CDM: Recommendation Form for Small Scale Methodologies (version 01)
(To be used for presenting questions/proposals/amendments to the simplified methodologies for small-scale CDM project activity categories)

<i>Date of SSC WG meeting:</i>	19–22 October 2010, SSC WG 28
<i>Title/Subject (give a small title or specify the subject of your submission, maximum 200 characters):</i>	Clarification on the determination of baseline fuel mix ratio for a new cogeneration plant
<i>Indicative methodology to which your submission relates (refer the items of Appendix B of the Simplified Modalities and Procedures), if applicable.</i>	AMS-I.C “Thermal energy production with or without electricity”
<i>Name of the authors of the query:</i>	Niroj Kumar Mohanty Institution: Core CarbonX Solutions Pvt Ltd nmohanty@corecarbonx.com

SSC-Submission number	SSC_475
Date when the form was received at UNFCCC secretariat	22 October 2010
Date of transmission to the EB	22 October 2010
Date of posting in the UNFCCC CDM web site	22 October 2010

Project activity diagram (Greenfield project)

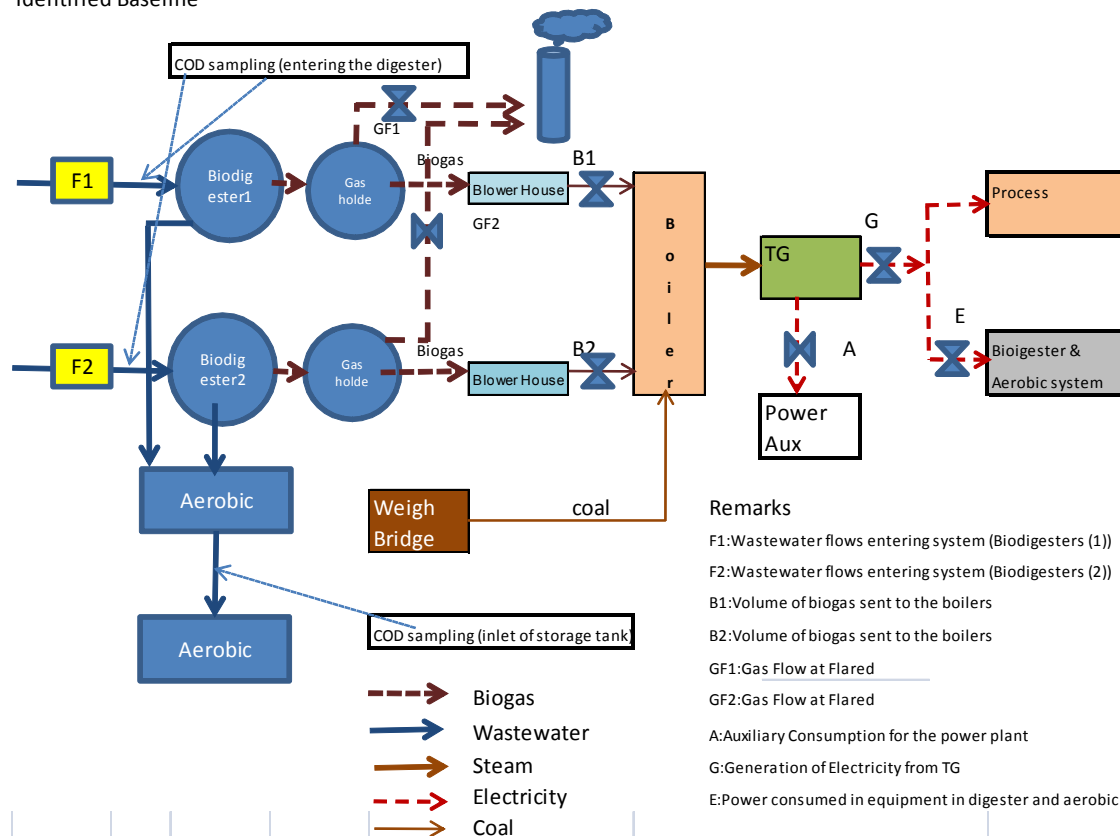
The distillery facility and project activity is a Greenfield project activity. Thus, there is no historical information available. This requires establishment of the most plausible energy supply sources in accordance with the guidance on Greenfield projects in the general guidance to SSC methodologies. Thus, the most plausible baseline scenario that has been identified is

- Coal would be cofired with biogas for steam and electricity generation. Coal would meet 70% of the total fuel inputs.

However, the project activity mentioned is a new captive cogeneration project and three year historical data is not available for the baseline fuel mix determination. Thus, baseline fuel mix and cofire emission factor can't be calculated as required by paragraph 26 of AMS I C.

Thus, clarification is sought whether baseline fuel mix can be determined without considering the approach mentioned in the paragraph 26 of AMS I C version 17 because the approach mentioned in the paragraph 26 is not suitable for a Greenfield project?

The SSC WG agreed that the baseline fuel mix for this new cogeneration project can be determined based on the maximum biogas production capacity of the distillery's bio-methanation plant, according to manufacturer's specifications, and the total energy demand of the project plant. The reference to the total energy demand here assumes that the PP has access to data on the total energy demand that will be met by the proposed cogeneration project. From the information made available in this submission, total energy demand will include: annual heat demand that will be supplied to the distillery process, the biodigester and the anaerobic process, as well as the electrical energy demand to power the auxiliary equipment at the refinery. From these data the energy share that can be met by the biogas will be determined, and the remainder will be the share that will be met by the other baseline fuel (eg. coal).

The SSC WG also agreed that the baseline fuel(s) shall be determined using "The Guidance on Greenfield Projects" which can be found in the "General Guidelines to SSC CDM methodologies". Although the author assumes that this baseline fuel will be coal, this will have to be demonstrated, following the steps provided in the guidance.

The SSC WG would also like to point out that since it is possible that the quantity of biogas that will be utilized in the pre-project situation may be different from the quantity that will be used in the project scenario then the bio-methanation plant should be included in the project boundary and any emissions related to the generation and utilization of biogas will have to be taken into account, using the approach in a methodology such as AMS-III.H "Methane recovery in wastewater treatment".
